Natural Resources Wales permitting decisions

**The First Milk Cheese
Company Limited
(Haverfordwest Creamery)**

Decision Document

The variation application number is: EPR/XP3830UR/V007 (PAN-019159)

Figure 1: proposed location of changes to the site layout

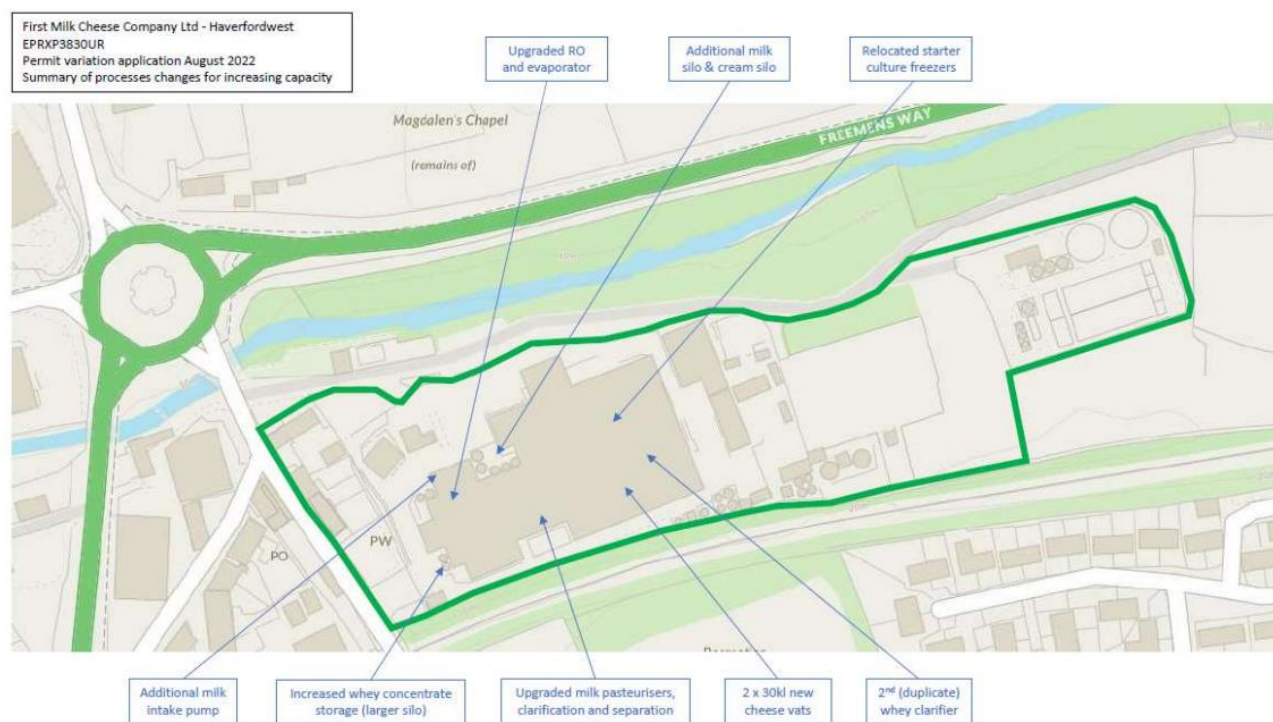
The proposed new milk and cream silos were to be located north of the existing silos closer to the site boundary (shown in more detail in figure 2).

The new cheese vats were proposed to be located indoors next to the existing cheese vats and are on hardstanding ground and with drainage to the effluent treatment plant. The new silos (milk, cream and whey) are located outdoors (on hard standing concrete) next to the existing silos. The new milk and cream silos being located north of the existing silos while the new whey silo is replacing the existing whey silo near the western boundary of the installation (Figure 1).

Although the site currently stores these substances in the same way, we consider that the additional volumes and location of the new milk and cream silos in close proximity to the site's north boundary would increase the risk of substances leaving the site boundary in the event of loss of primary containment. It was also considered that although whey is more viscous and has a lower mobility, there is a potential impact pathway through leaked whey being carried by rainwater if the primary containment fails.

Figure 2: site drainage plan with the location of the new silos and vats

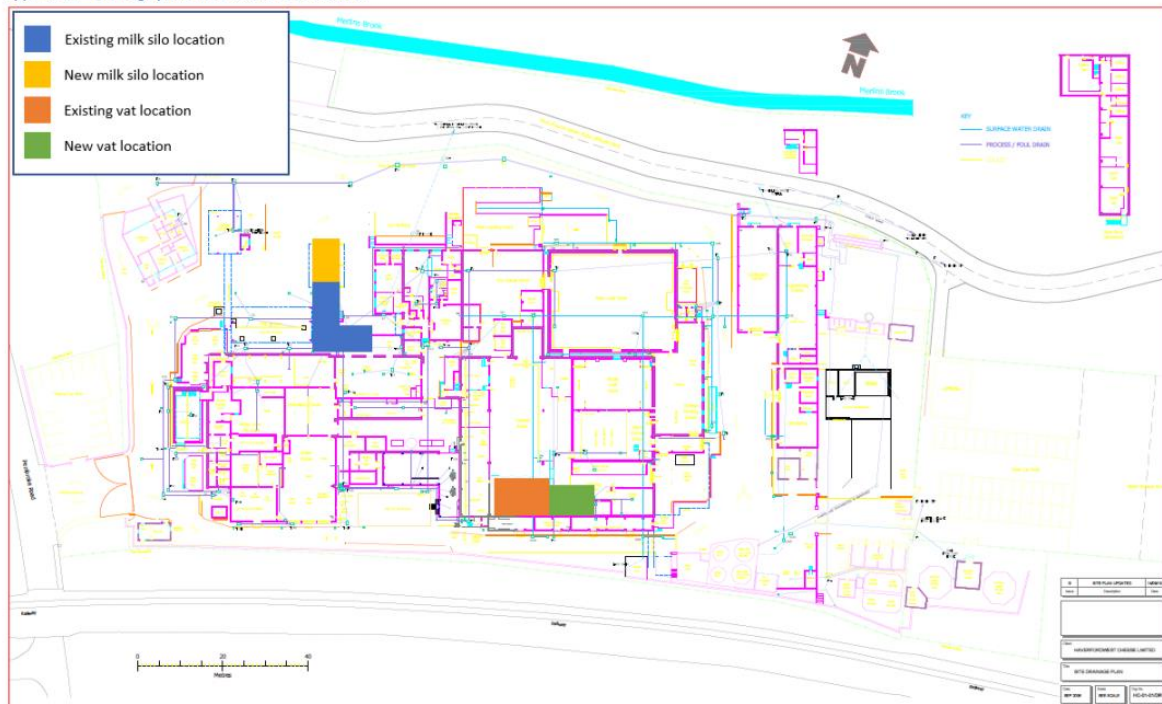
- 1) The proposed (new) silos would not have any secondary containment (as stated by the applicant) to contain spillage of milk, cream and whey in the event of a leak from either the silos or the associated pipework. In the event of loss of containment from the silos the operator has not demonstrated that the leak would be fully contained and prevented from entering the environment by the “*other appropriate measures*”, i.e., *the hardstanding surfacing and site drainage*.

- 2) Without secondary containment (in the form of bunding, for example), there is no way of ensuring that the spill would be retained at the base of the silo.

- 3) In addition to the points raised on secondary containment, the applicant has not proposed any changes to tertiary containment. The site's tertiary containment consists of hardstanding concrete and site drainage up to the northern entrance and to the effluent treatment plant. Effective tertiary containment depends on the site drainage containing and diverting flows to the effluent treatment plant, in the event of loss of the primary containment. However, we do not agree that this alone is sufficient enough justification for not having secondary containment, without additional information on the ability of the site drainage to divert flows to the effluent treatment plant or retaining tanks (which is discussed in more detail later on in the section on [Other appropriate measures to secondary containment](#)).
